**SUBJECT** APPROVED REVISED CONCEPT REPORT

REVISED PROJECT CONCEPT REPORT

Danforth Road Transit Oriented Sidewalks

Project Number: CM000-00BK-00(042)

# ATTACHMENT 4 REVISED TYPICAL SECTION

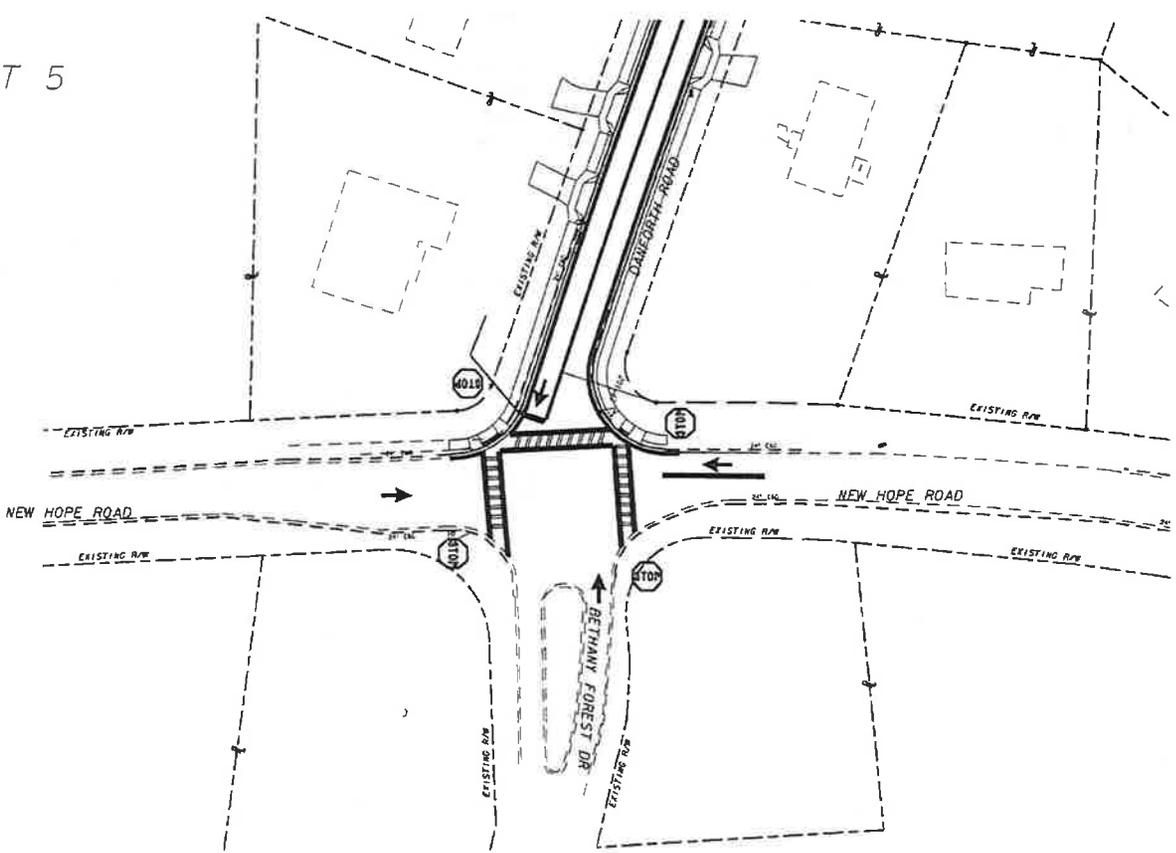
**Proposed Features  
Typical Section(s):  
See Attachment 4 and 5**

During meetings conducted with the Neighborhood Association in January, 2010, the City of Atlanta acquiesced to deletion of the traffic signals. Fulton County had installed 4-way stop signs at the intersection after the flood of September 2009 and the community is quite satisfied with this condition. Because of the deletion of the signals, the proposed turn lanes were also eliminated.

The City also decided to extend the project, on the south side of Danforth Road, another one thousand five feet (Sta. 130+05 to Sta. 140+00) to the east. The sidewalk on this side will tie to the existing sidewalk west of the Reunion Place subdivision. The extension of the project will include similar shoulder, curb and gutter, and sidewalk widths, included in the approved concept. The sidewalk on the north side will end as shown in the approved concept.
